SERVICE BULLETIN # 1004

SUBJECT Coils

New coil test readings

MODEL ALL DATE 10/9/57

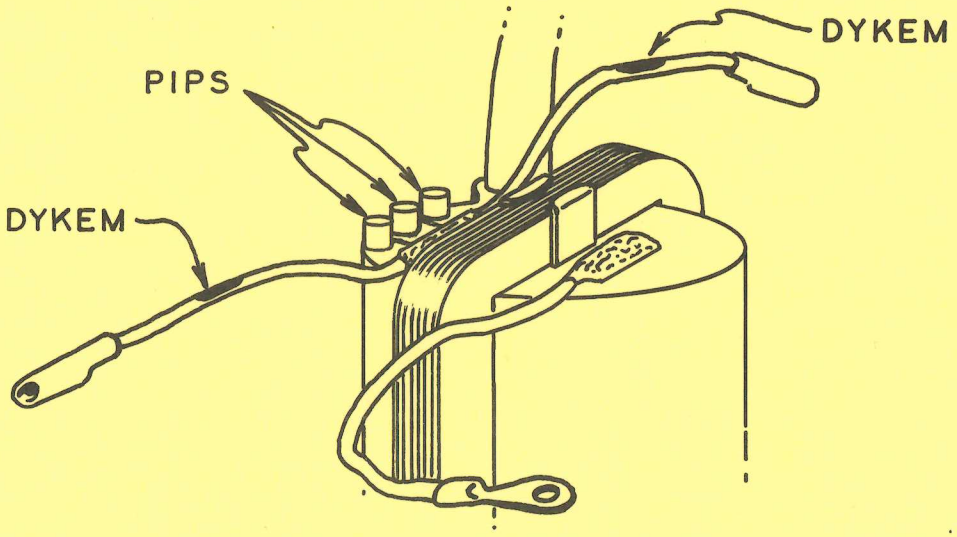
A recent change in the secondary winding of McCulloch coils reflects a change in readings when the coil is placed on a coil tester for checking. Coils with the indicated change are identified by pips on the coil case (See Illustration,) or have been spotted with Dykem on the breaker point and/or switch lead on the coil.

The following test readings, comparing coils with secondary winding change and coils of previous manufacture, are based on tests made using a Graham Model 51 Coil and Condenser Tester. For all practical purposes, the same approximate variance in secondary readings should be indicated on all testers., when checking the new coils.

New Coil		Present Coil
2400 ohm	Secondary	4400 ohm
.7 ohm	Max. Primary	.7 ohm
60-63	Index	50
14	Test	11-12

Until further notice, the above test readings will be considered valid when checking coils for acceptable condition.

To avoid possible error when checking coils, place information regarding the identification of coils and test readings by your coil tester.
